**1 Products affected**

**2 Type of change**

Product Change Notification					PCN Fusedrawer 2		
owner	creation date	release date	released by	change order no	rev	page	D10-017-137
sariogar	21.09.2017	22.09.2017	buerglal	2013754	C	1 of 3

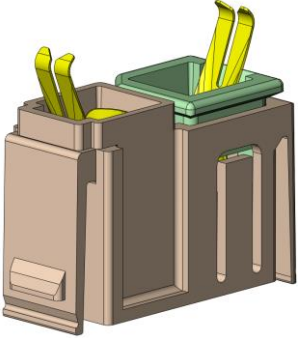
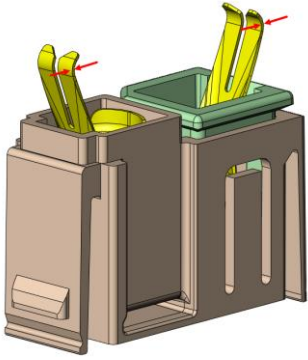
Old contact spring thickness 0.20 mm	New contact spring thickness 0.25 mm

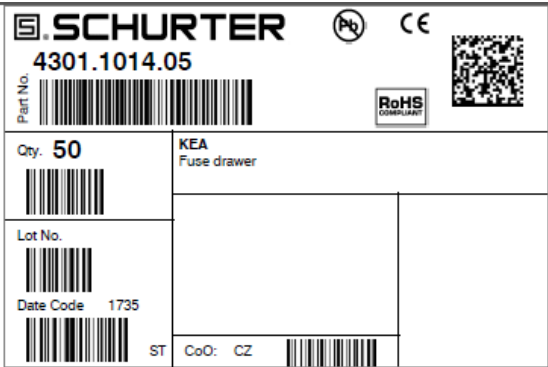
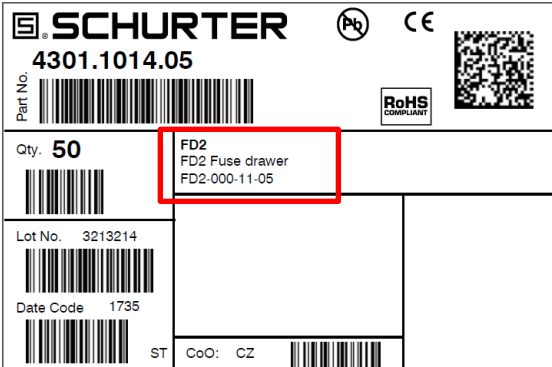
Old voltage selector insert white	New voltage selector insert changed to black colour

Old label	New label
	<p>Name and description adjusted. Configuration code added.</p>
